Michael Johnston, representing Joe Glenn, requests a Plat Amendment for Deer Mountain Resort Lot 35 to amend the storm water easement that runs through the lot from 120 feet wide to 40 feet wide. (PLAN-PlatAm-26-002)

Deer Mountain Resort Lot 35 storm drain easement Minor Plat Amendment

Project: PlatAm-26-002 | Lot 35 Deer Mountain Resort
Report Date: 11 May 2026
Report Author: Doug Smith, Planning Director
Council Action Required: No
Type of Action: Administrative

LOT 35 AMEN

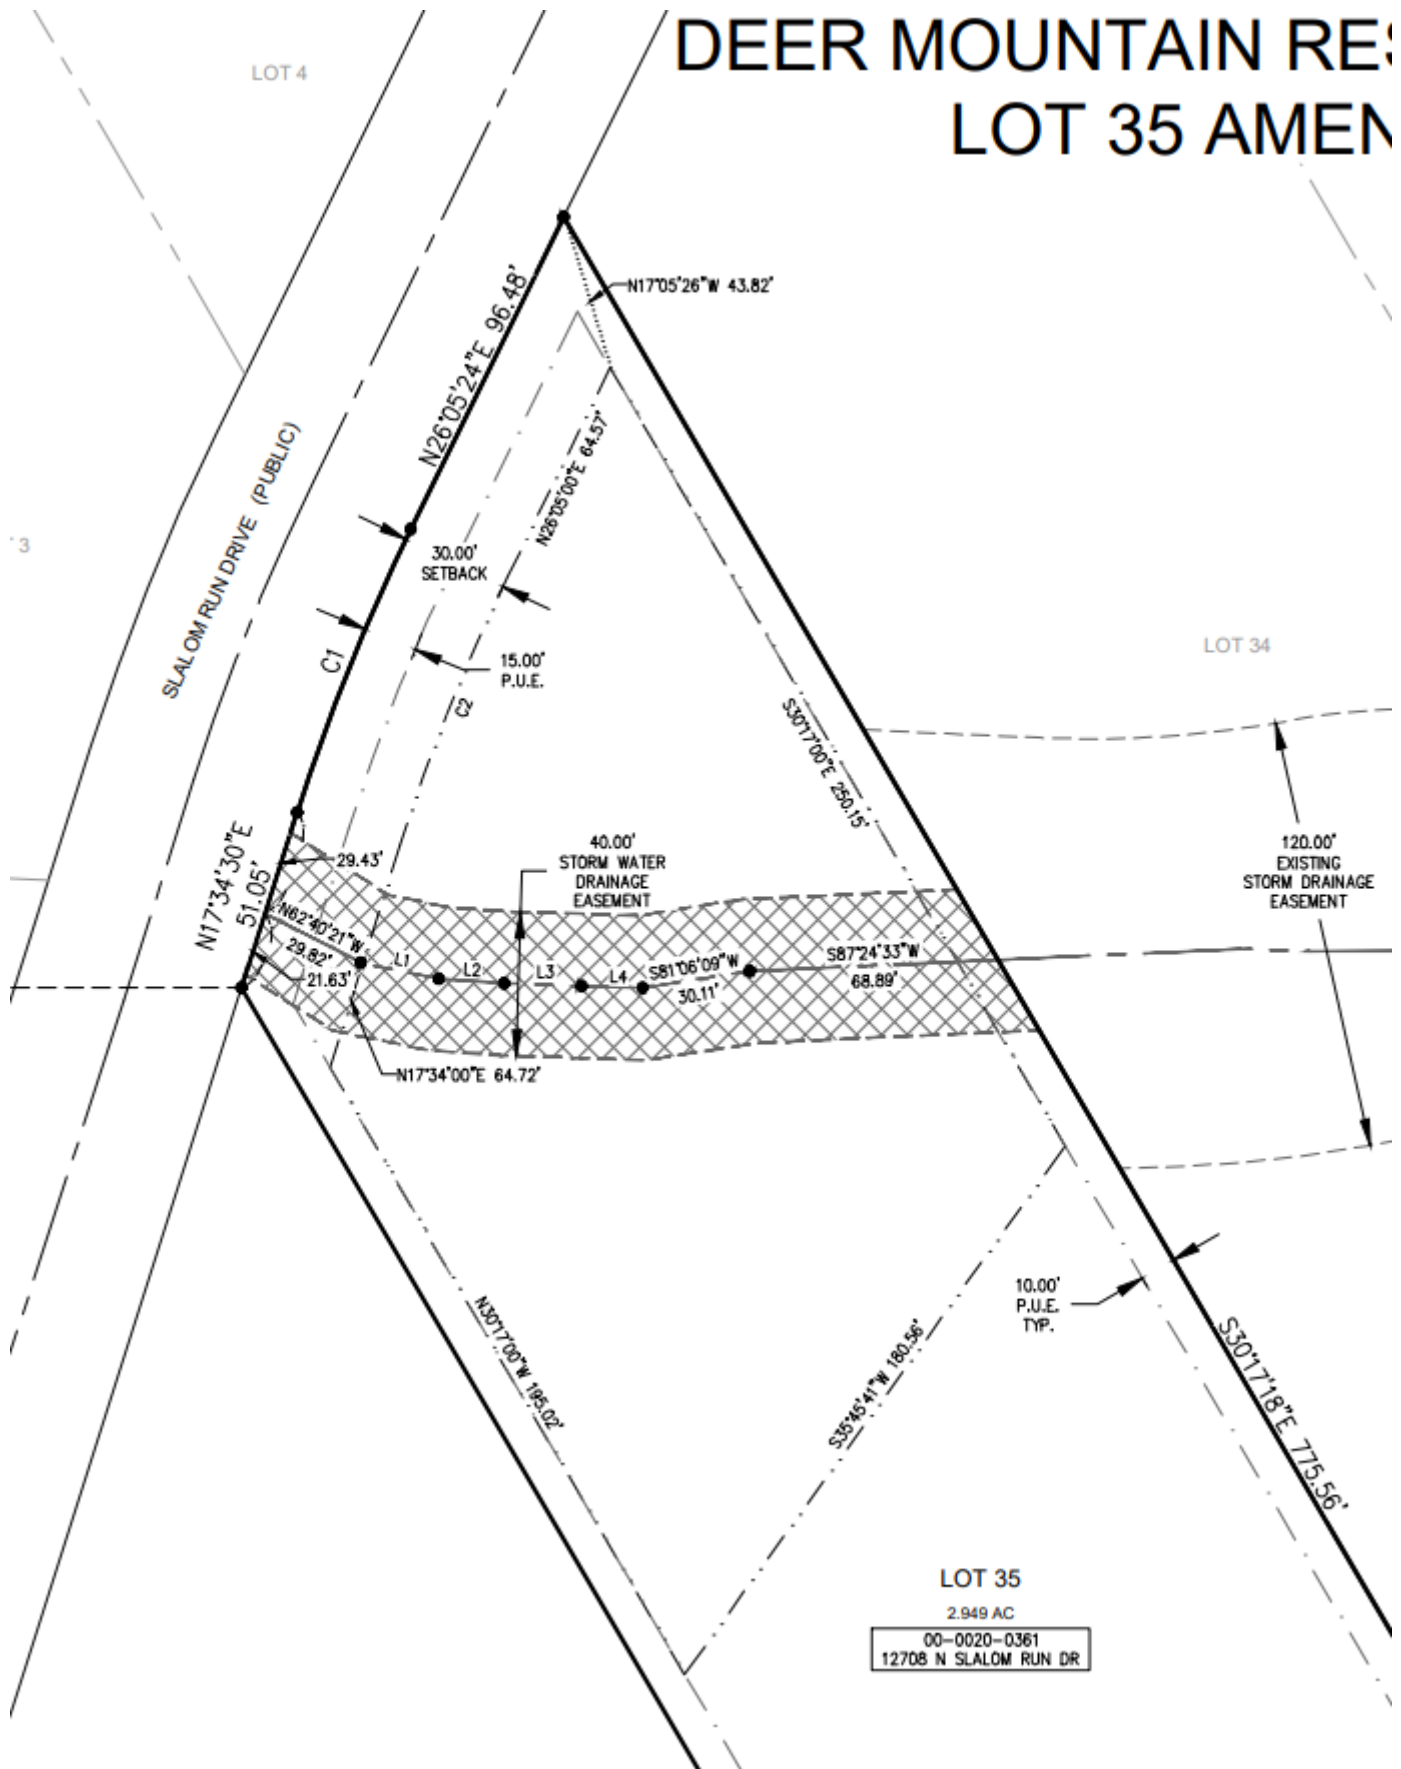
Proposed Plat			
- The street name is spelled wrong. - The note refers to this as a flood plain. It is not a FEMA regulated channel. - Please refer on the note to a storm drainage easement. - The rip rap is 30' wide. The easement should be 50' wide in case there ever needs to be repair done on the rip rap.			
Proposed Plat	04/02/26 - Doug Smith	- Rejected	- Current code requires a 15' front PUE. - The r - See additional Notes

- Current code requires a 15' front PUE. - The road labeled in the front is misspelled - Please change the note on the plat to storm water not flood plain. This is not a flood plain. - Due to the need to maintain the rip rap we recommend that a 40' easement be noted on the plat.			
Fire Department

Item	Comments		
Proposed Plat	03/31/26 - Tori Lewis	- App W/Cond	- see additional notes
The Project Location is called out incorrectly. This project falls in the Northwest 1/4 of Section 8, not the Northeast. (Shown Correctly on Record of Survey).

We have increased the storm drainage easement to 40-ft wide, as requested

Street name corrected. As requested, we have changed the easement crossing the other lots to be a "Storm Drainage Easement."

15' front PUE shown. Street name corrected. As requested, we have changed the easement crossing the other lots to be a "Storm Drainage Easement."

Done

Exhibit E – Aerial of drainage

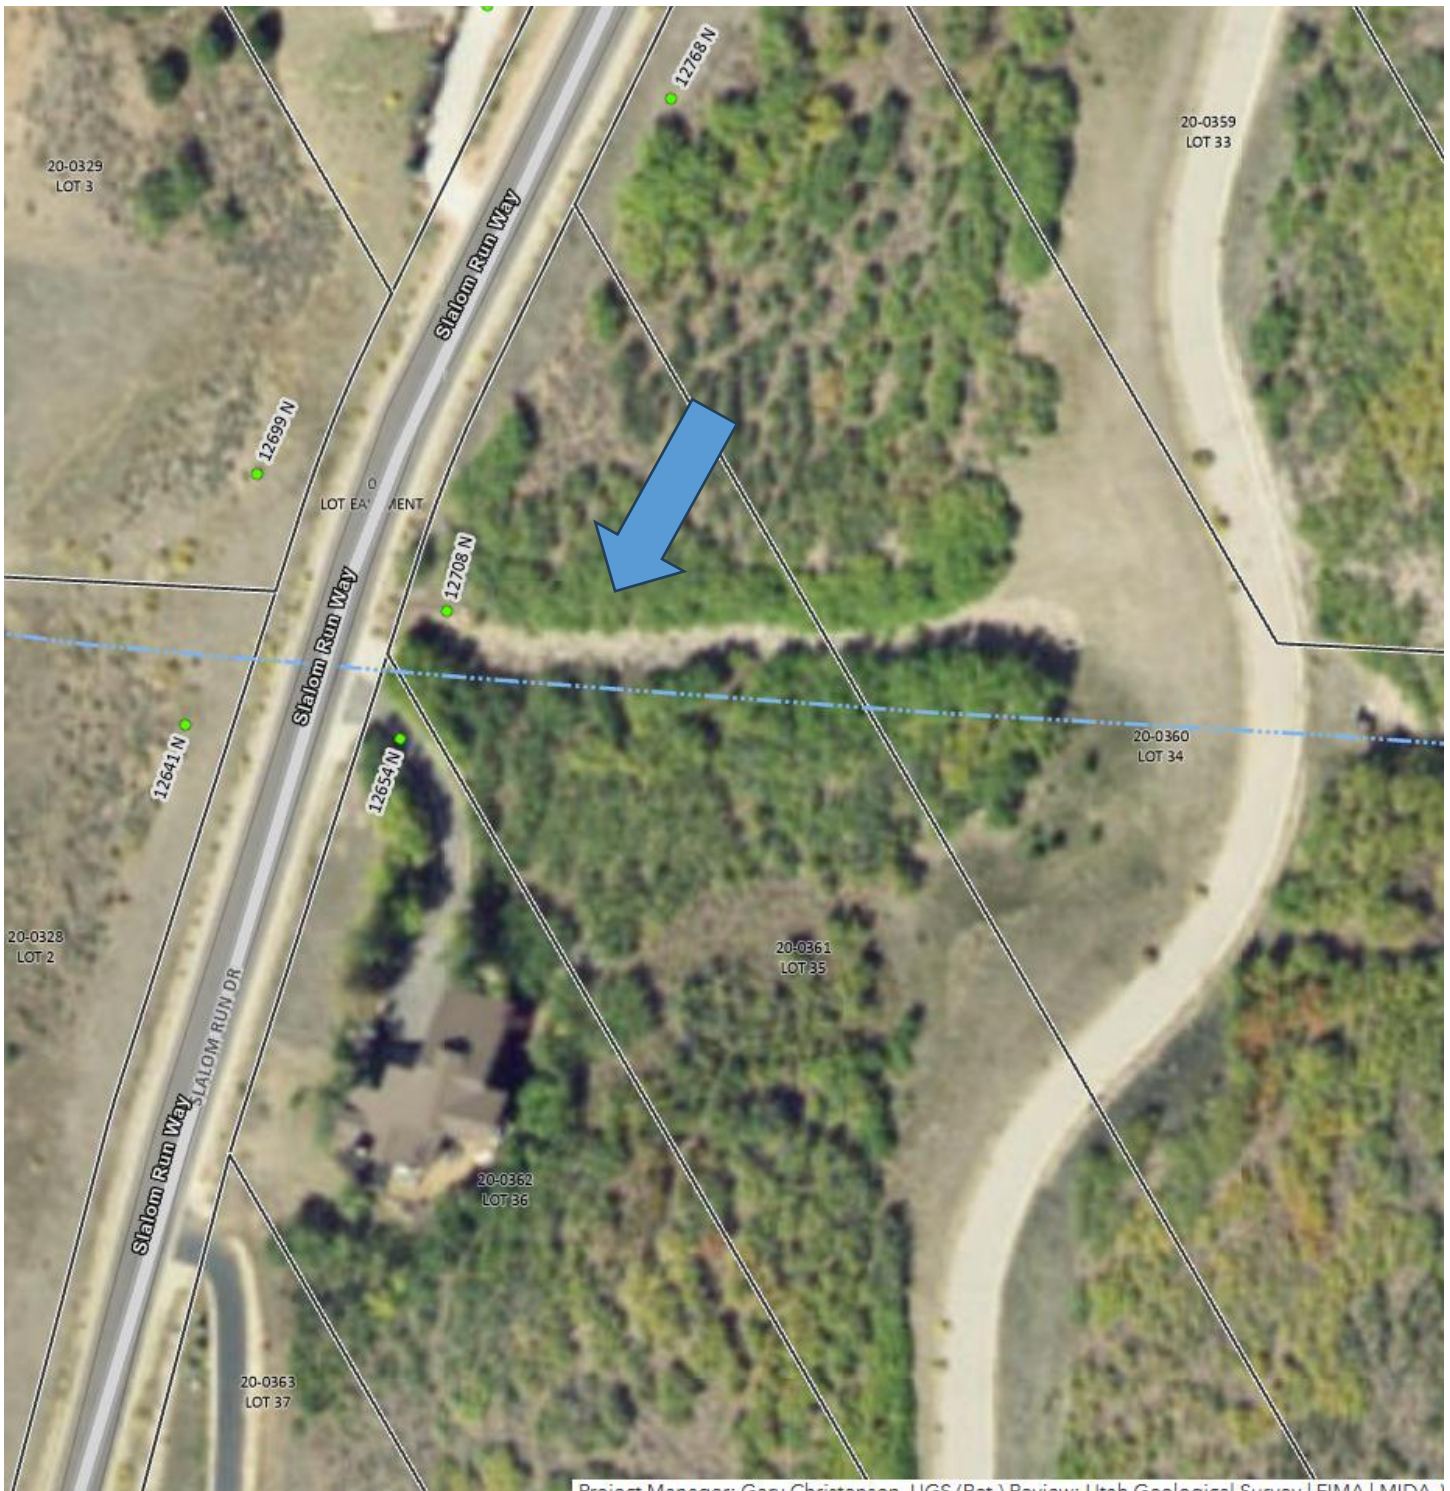
Engineering			
Item	Comments		
Letter of Request	04/02/26 - Devin Earl	- Rejected	- The existing channel has a width of at least 20-feet - See additional Notes
The existing channel has a width of at least 20-feet in a few places and a 30-foot easement would hardly provide any additional room for access if maintenance, cleanout, or repair is needed. The downstream easement is 60-feet. Recommended to increase total easement width to 40-feet (20-feet each side of drainage centerline) to help facilitate access and maintenance if needed. Otherwise agree with reasoning for plat amendment.			
Proposed Plat	04/02/26 - Devin Earl	- Rejected	- Please revise easement to be 40-feet wide to allow - See additional Notes
Please revise easement to be 40-feet wide to allow for 20-feet each side of drainage centerline to accommodate space outside the existing rip-rap for access to maintain or repair drainage if needed. Please submit hydraulic calculations as referred to in Plat Note No. 2.

The entire reason this plat amendment was requested is to recognize that gully is a drainage easement and NOT as stream. There is NO SETBACK required from this gully. The 40-ft easement is sufficient for safety and for maintenance.
